> In reply refer to: P-405-MD NATDAM #MD00097 Conowingo Project

Subject: 2024 Dam Safety Inspection Follow-up

Photo 1 – Deposit of debris and vegetation in the spillway gate structures (found in most of them)

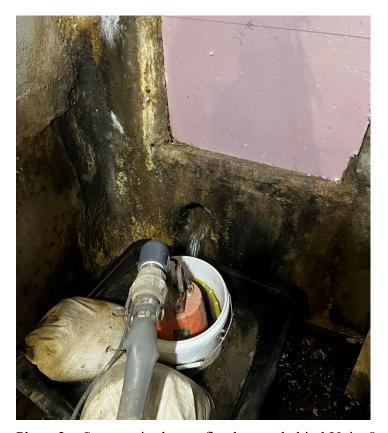
- 1. Deposit of debris and vegetation were found on most of the spillway gate structures (Photo 1). Please clear all debris and vegetation from the gates prior to the next inspection and implement a routine maintenance program for the same.
- 2. Seepage in the confined space behind Units 8 to 11 that was noted during the 2023 inspection continues to occur, but it is now being collected and pumped into a drain (Photo 2). We understand that a dye-test investigation is being planned to assess the source of the seepage as per our 2023 inspection recommendations. Please submit the results of dye test when it is available.
